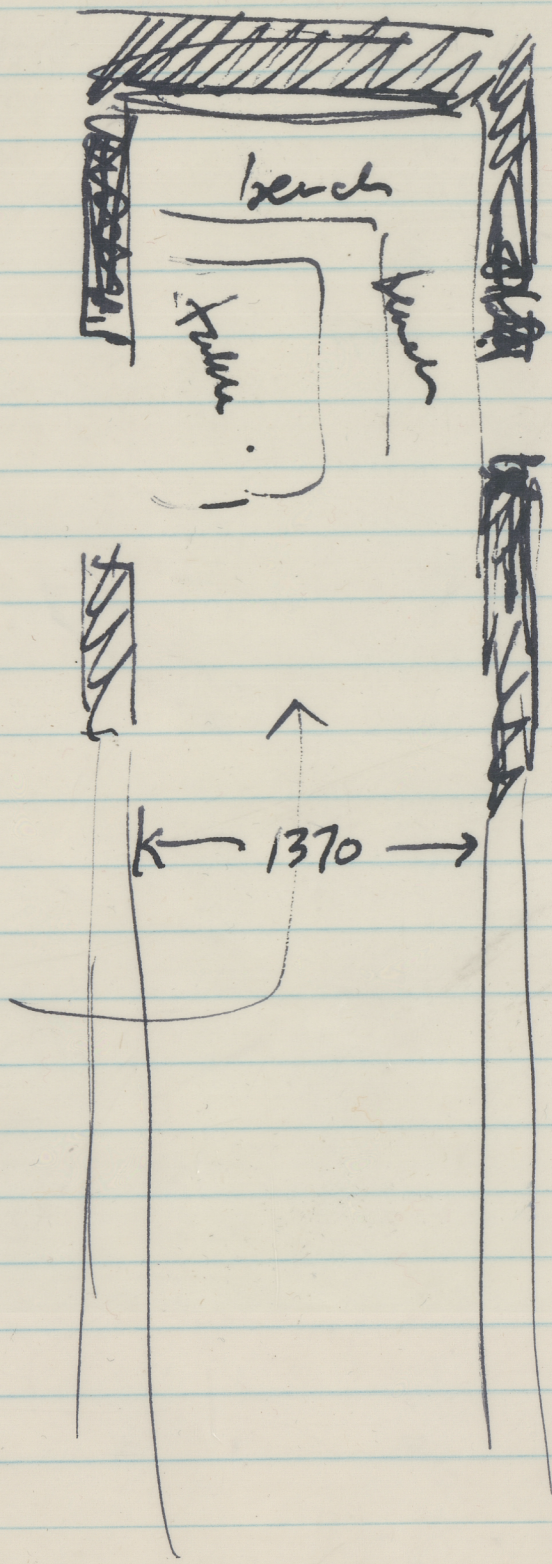
1 see
no problem
with
this
kind of
arrangement
for the
end bay.
